**Subject: MHI's Revised Responses to US-APWR DCD RAI No. 585-4464 Revision 0  
(SRP 09.02.01)**

Revised Responses to Request for Additional Information  
No. 585-4464 Revision 0

**US-APWR Design Certification  
Mitsubishi Heavy Industries, Ltd.  
Docket No. 52-021**

Figure 9.2.1-1 Essential Service Water System Piping and Instrumentation Diagram (Sheet 1 of 3)

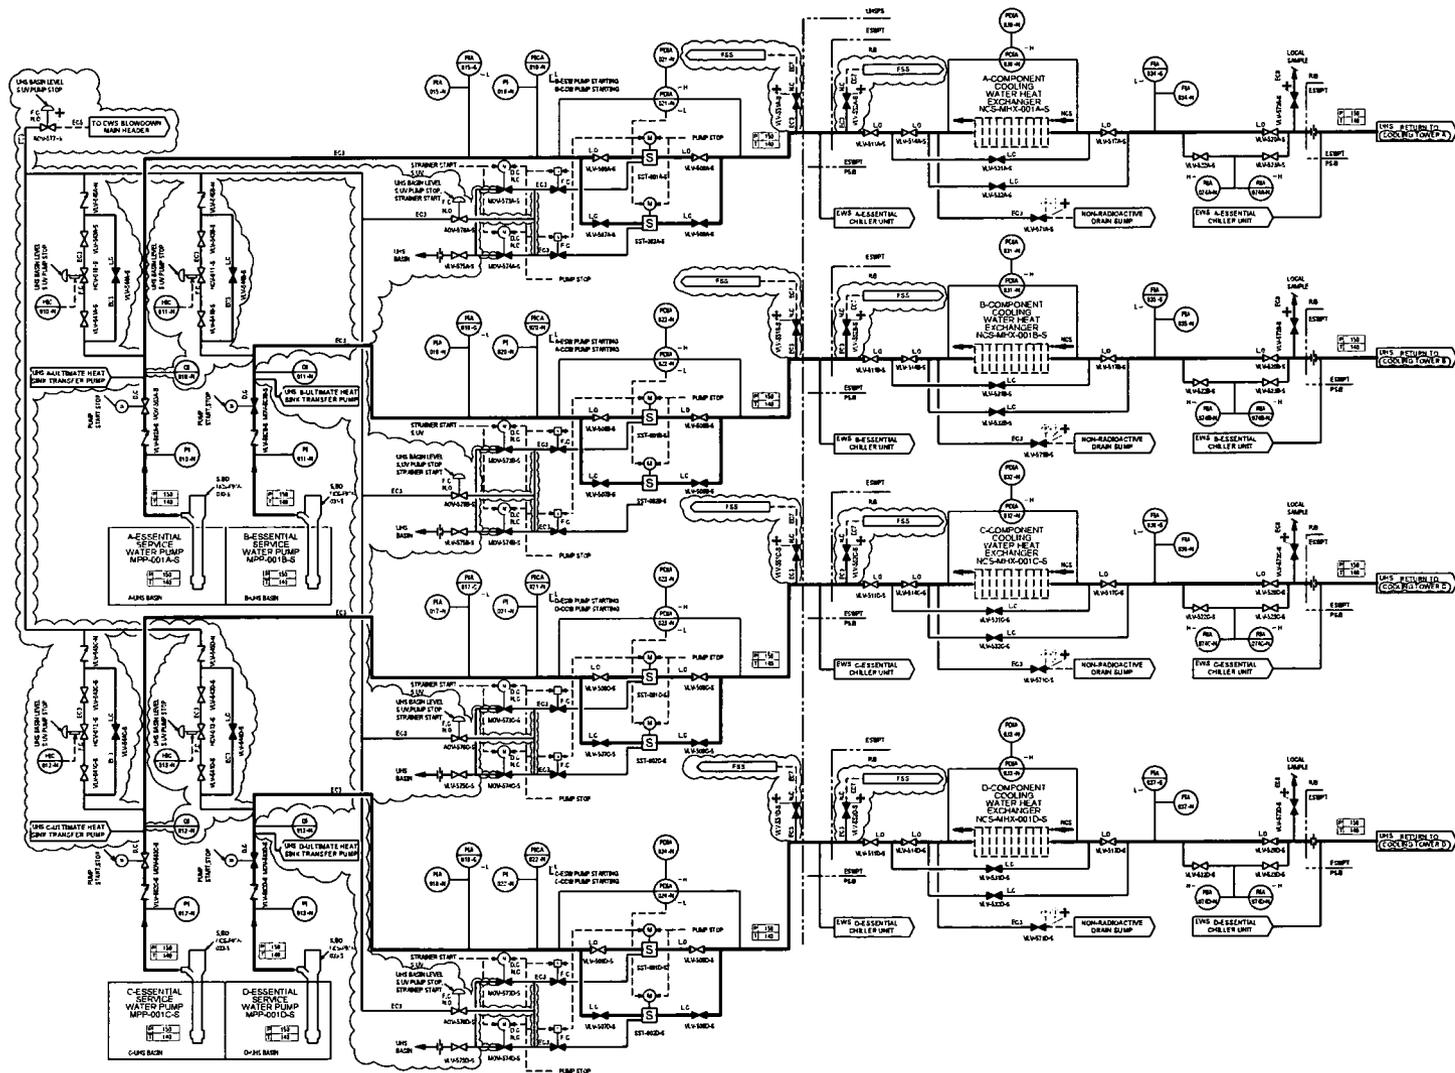
**Question: n)** Section 9.2.10, COL 9.2(7) indicates that the COL applicant is to provide piping and valves, including those at the boundary between safety-related and nonsafety-related portions related to site-specific conditions. It isn't clear what this item is referring to and to what extent it applies to that part of the ESWS that is within scope for the standard plant design, such as vents and drains.

b) The staff noted that Tier 1 of the DCD Figure 2.7.3.2-1 did not show many of the important system components, such as the radiation monitors, the strainers and piping for flushing the CCW strainers. A level of detail needs to be provided in the Tier 1 drawings of the DCD in order to meet inspections, tests, analyses, and acceptance criteria (ITAAC) commitments for verifying system configuration. The applicant stated that a revised figure will be included containing the same level of detail. However, upon review of revision 2 of the DCD, the level of detail of Tier 1 drawings still appear to be inadequate, and Tier 1 Figure 2.7.3.2-1 appears to be an incorrect figure number. Therefore, this item will remain open pending a satisfactory response to this RAI issue by the applicant.

The CCW heat exchanger drain connections, including drainage points, are all SPDI and have been described in DCD Figure 9.2.1-1. The Safety and Non-safety boundaries have been clearly delineated by adding the class boundary symbol delineating the first normally closed valve drain connection as "EC3" in DCD revision 3.

With regard to vents and drains, local vent/drain lines cannot be determined until the detail design phase, therefore, the design of vent/drain is not within the standard plant design. Actually, in the DCD revision 3, the system drawing has been simplified and local vent/drain lines have been deleted from the system drawing or will not be added to the drawing to prevent having to make any minor changes to the DCD as local vent/drain lines.

All instrumentation available in the main control room are also provided locally. DCD revision 3 Figure 9.2.1-1 has been appropriately revised to reflect that all instrumentation available in the MCR has local read out. The statement that all instrumentation available in MCR also has local read out will be added to DCD revision 3 Subsection 9.2.1.5.

- Subsection 9.2.1.2.2.2 is revised to state that Figure 9.2.1-1 has the valve ID markings to match the DCD description to make it clear which valves are being referred.

- The ESW flow rate to the CCW heat exchanger indication is safety-related and available in the MCR. This indication, EWS-FIA-034-S, 035-S, 036-S, 037-S which is shown in Figure 9.2.1-1, aids the operator in identifying the need for strainer backwashing. There is also a low flow rate alarm to indicate the reduction of the CCW heat exchanger performance due to the low flow rate compared to the design value of 11,000 gpm.

- The strainer swapping operation is completed.
- The inlet and outlet isolation valves for the strainers shown on Figure 9.2.1-1 do not have remote valve operator symbol; the valves can be identified as local manual valves.
